**Woodlawn Advanced Energy Recovery Centre (SSD-21184278)
Additional Information required following review of Environment Impact Statement**

Attachment A: EPA information requirements following review of Woodlawn ARC EIS

Figure 2: Projected emission intensity of the NSW grid (DCCEEW, 2021⁶)

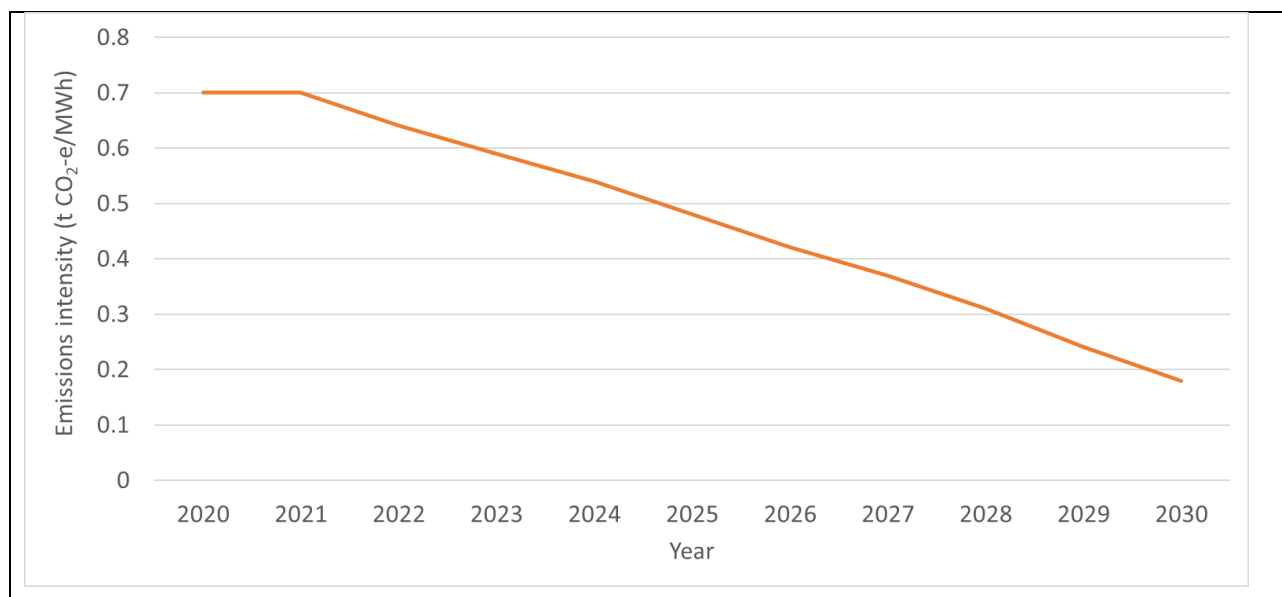
The ARC project is expected to commence operation in 2026, with a design life of 25 years. The NSW electricity grid is undergoing rapid decarbonisation. Projections published by the Department

of Climate Change, Energy, Environment and Water (DCCEEW)⁵ and shown in Figure 2, indicate that, at project commencement in 2026, the emission intensity of the NSW grid will be 0.42 kg CO₂-e/kWh (53% of the current (2021) scope 2 emission intensity). Furthermore, in 2030, the NSW grid emission intensity is projected to drop to 0.18 kg CO₂-e/kWh (23% of the current scope 2 emission intensity). Further reductions in the emission intensity of the NSW grid are anticipated after 2030 given the announced closures of the remaining coal-fired power stations. Therefore, for the life of the project, the emission intensity of electricity generated from the project is likely to be higher than the emission intensity of the NSW grid, contrary to what is concluded in the greenhouse gas assessment.
